ADDENDUM NO. 1
February 28th, 2025

**PROJECT: EULA INDEPENDENT SCHOOL DISTRICT
AG RENOVATION & ADDITION**

BID DATE: MARCH 6th, 2025 AT 2:00 PM

POWER FLOOR PLAN

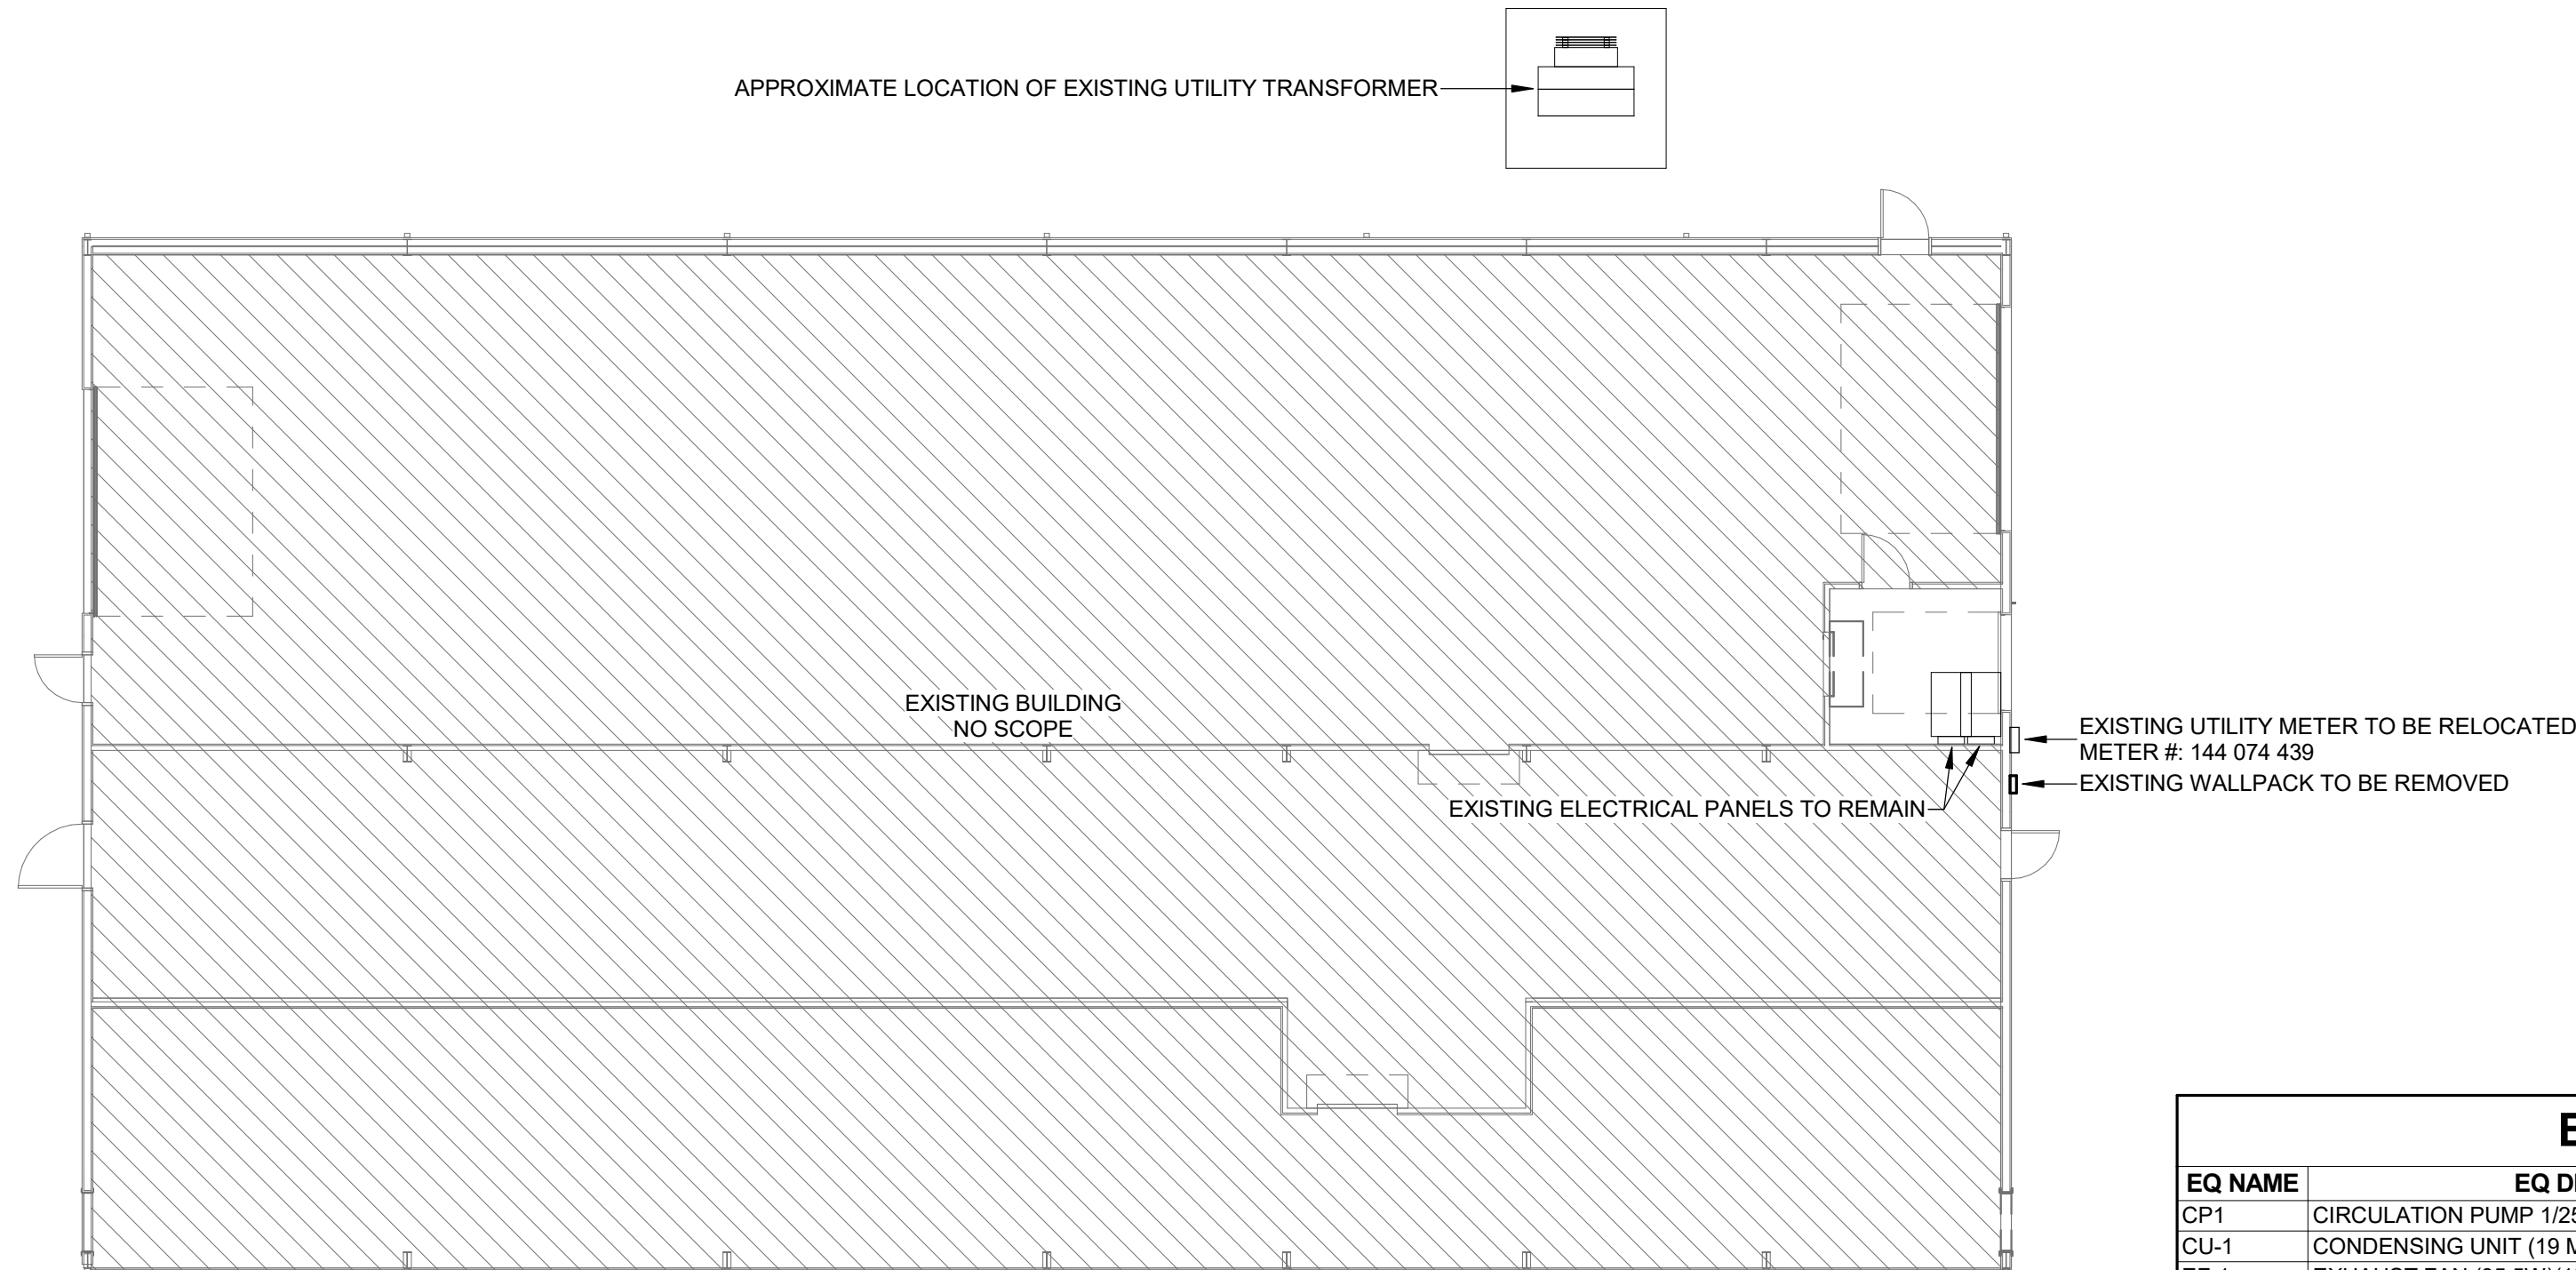
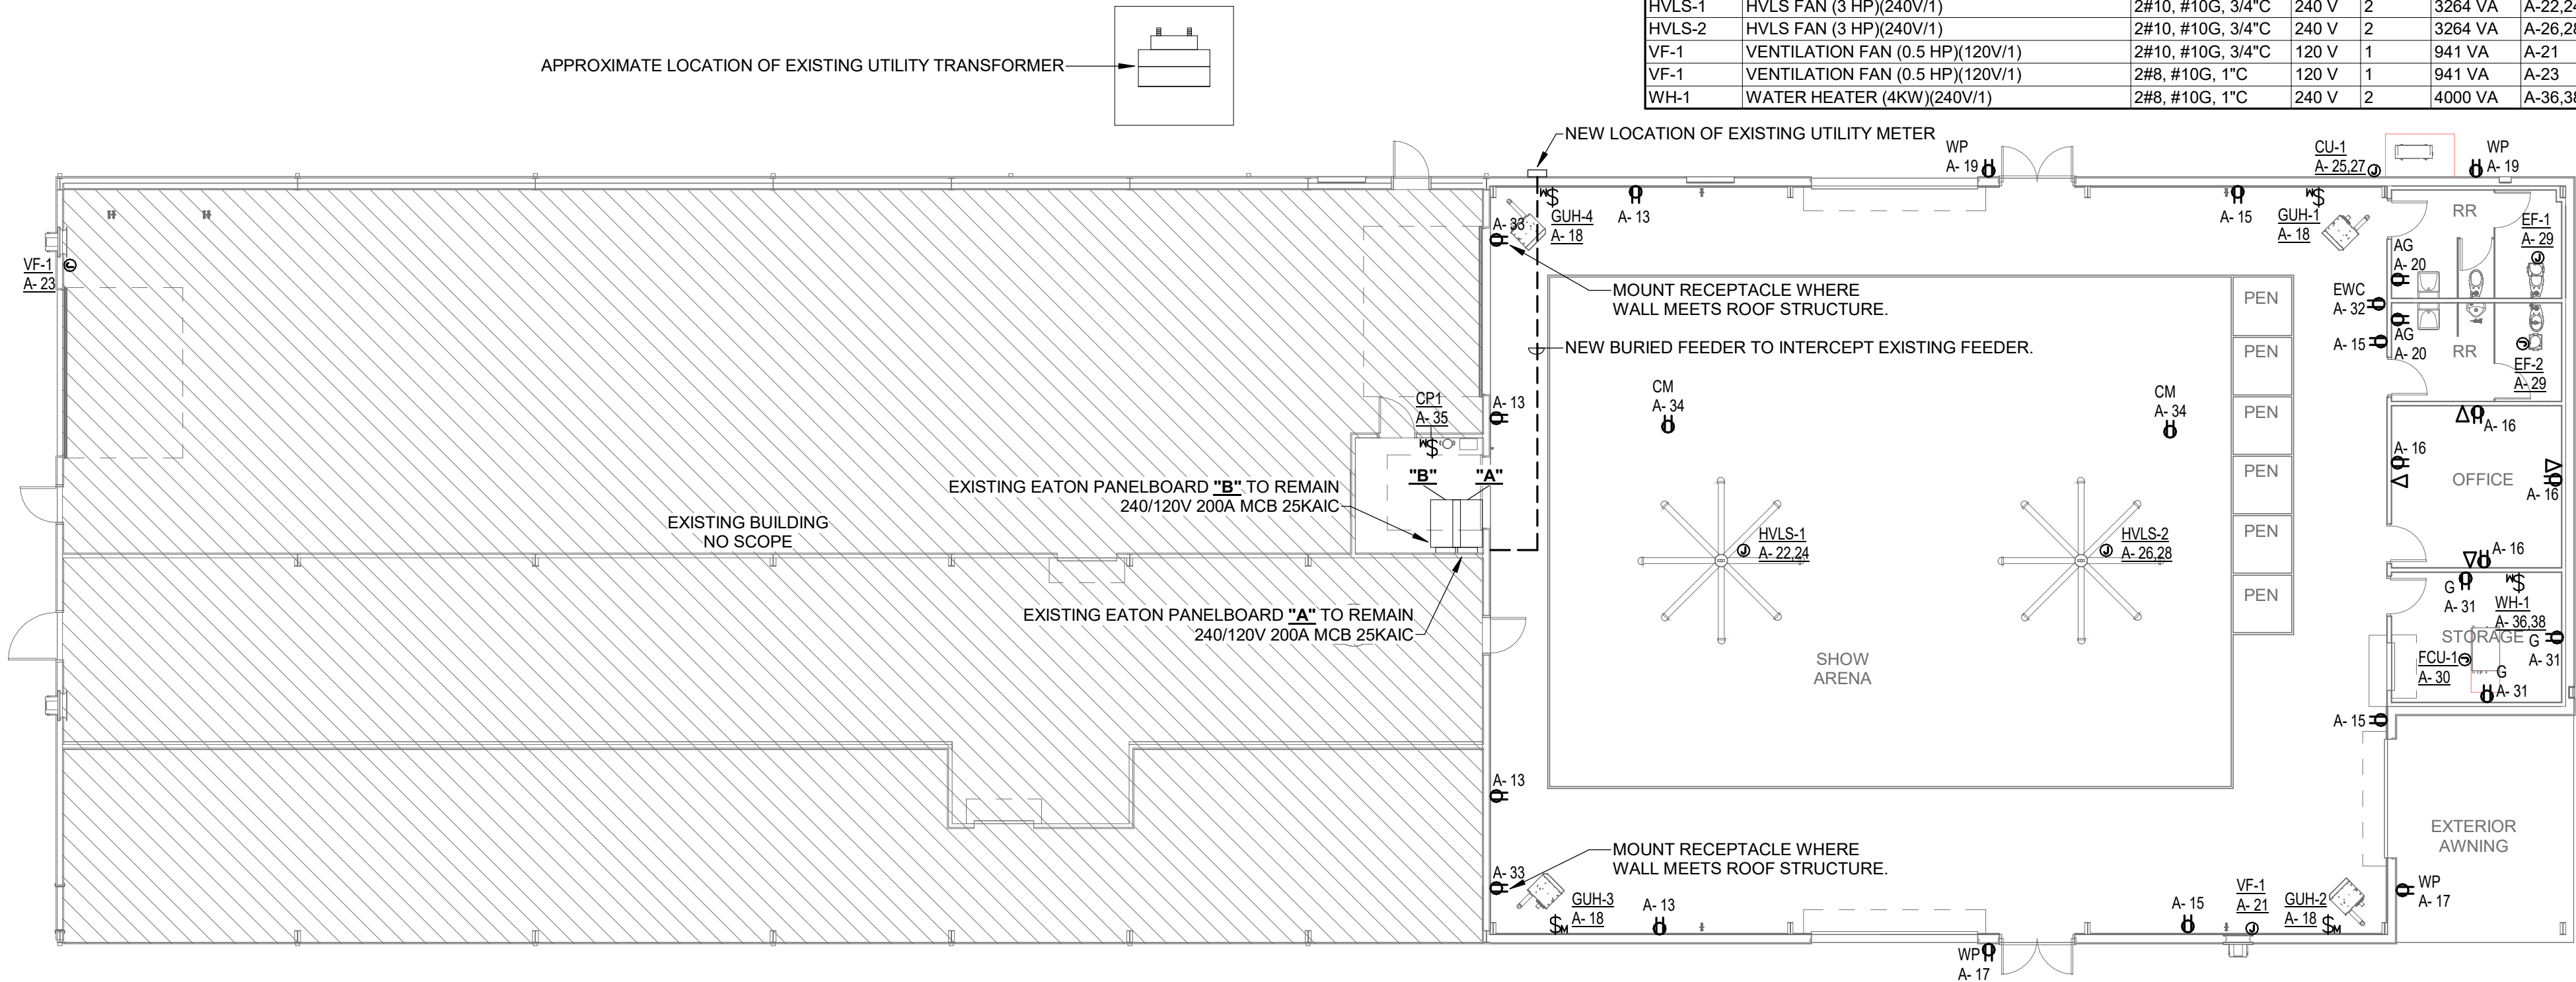
- Item #D1** Sheet A2.1 – REPLACE sheet with attached sheet A2.1 dated 02-28-202. UPDATED keyed note 10.
- Item #D2** Sheet A2.2 – REPLACE sheet with attached sheet A2.2 dated 02-28-2025. ADDED missing elevations. UPDATED Duraplate note.
- Item #D3** Sheet E1.0 – REPLACE sheet with attached sheet E1.0 dated 02-28-2025. UPDATED general power notes.

Item #Q1 **Question:** Sheet E1.0 shows the existing meter to be relocated. The meter currently feeds two, 200A panelboards. To satisfy NEC requirements, we will need to add a main disconnect switch adjacent to the meter at the new location and we will also need to provide overcurrent protection for the conductors that refeed the existing panelboards. The easiest way to achieve this is to install one 400A N3R panelboard with a main circuit breaker and two, 200A circuit breakers. If this is acceptable, please specify the desired AIC requirements on the new main panelboard and sub-breakers. If this is not acceptable, please specify an acceptable solution with a single line diagram?

Answer: NEC 230.70(A)(1) calls for disconnecting means to be in a readily accessible location. NEC does not provide distances or any other clarifications on this excerpt. Electrical engineer's position is the plans as shown are compliant with this code.

- UTILITY SHALL DISCONNECT AND RECONNECT EXISTING UTILITY METER. CONTRACTOR TO CALL UTILITY FOR DISCONNECT DATE THAT FITS CONSTRUCTION SCHEDULE. DISCONNECT DATE CAN ONLY BE SCHEDULED 60 DAYS AHEAD.
 - VERIFY/COORDINATE ALL OTHER DETAILS OF DISCONNECT/RECONNECT WITH UTILITY.
